# Facility: Grissum Building

Date of Survey: 07/01/11

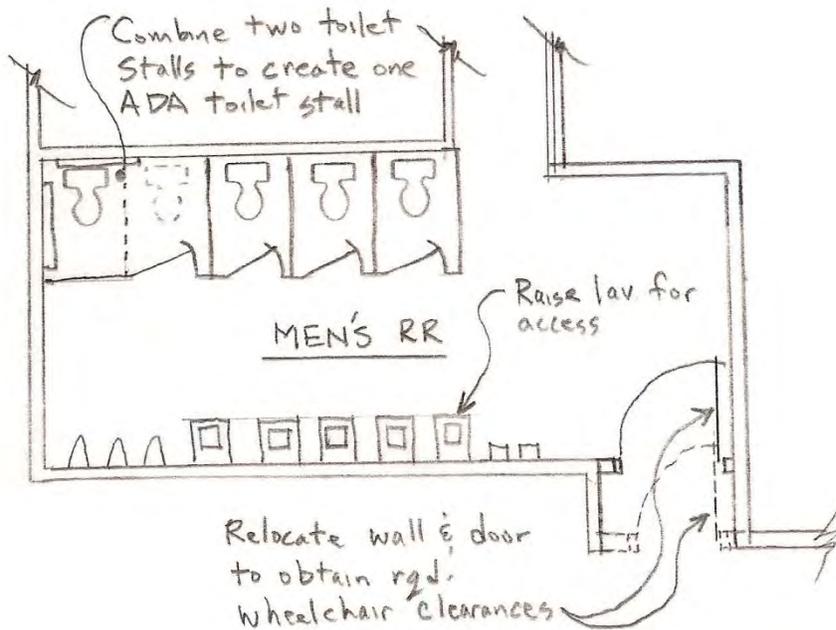
- Men's Restroom: Relocate entry door and wall so that it is flush with the wall that the lavatories are on to create wheelchair clearances at the door required by ADAAG 4.13.6, install a braille/tactile ADA restroom sign at the latch side of the door and mounted to be 60" from floor to centerline of the sign, adjust the door closer to open with 5 lbs. force or less, raise one lavatory to provide proper knee clearances per ADAAG 4.19, insulate the pipes below the ADA lavatory, lower the mirror at the ADA lavatory so that the lowest reflective surface is no higher than 40" a.f.f., and combine two end of the row toilet stalls and reconfigure to create one ADA toilet stall that meets ADAAG Fig. 30 (a), including the installation of grab bars (see sketch below).
